MSP430F5519 Device Erratasheet

The revision of the device can be identified by the revision letter on the [Package Markings](#) or by the [HW_ID](#) located inside the TLV structure of the device

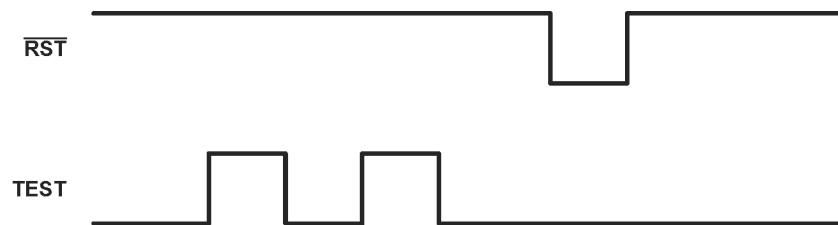
Description

The methods used to exit the BSL per MSP430 Programming Via the Bootstrap Loader ([SLAU319](#)) are invalid.

Workaround

To exit the BSL one of the following methods must be used.

Function BSL entry sequence is subject to specific timing requirements

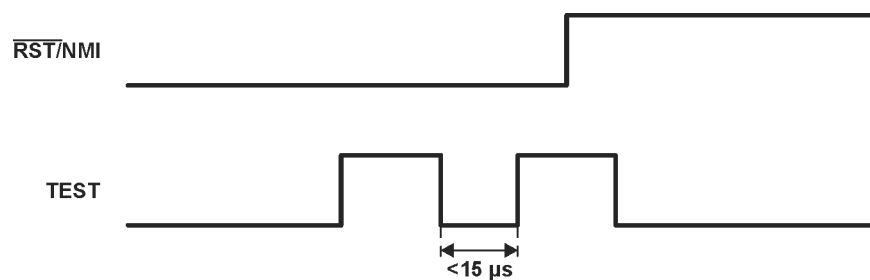
Description The BSL entry sequence requires that the low phase of the TEST/SBWTCK pin does not exceed 15us. This timing requirement is faster than most PC serial ports can provide, as shown in the following picture. If this requirement is not met, the entry sequence fails and the SYSBSLIND is not set.

Workaround An external hardware solution is recommended to provide the appropriate BSL entry sequence. See [http://processors.wiki.ti.com/index.php/BSL_\(MSP430\)](http://processors.wiki.ti.com/index.php/BSL_(MSP430)) for recommendations on available BSL hardware.
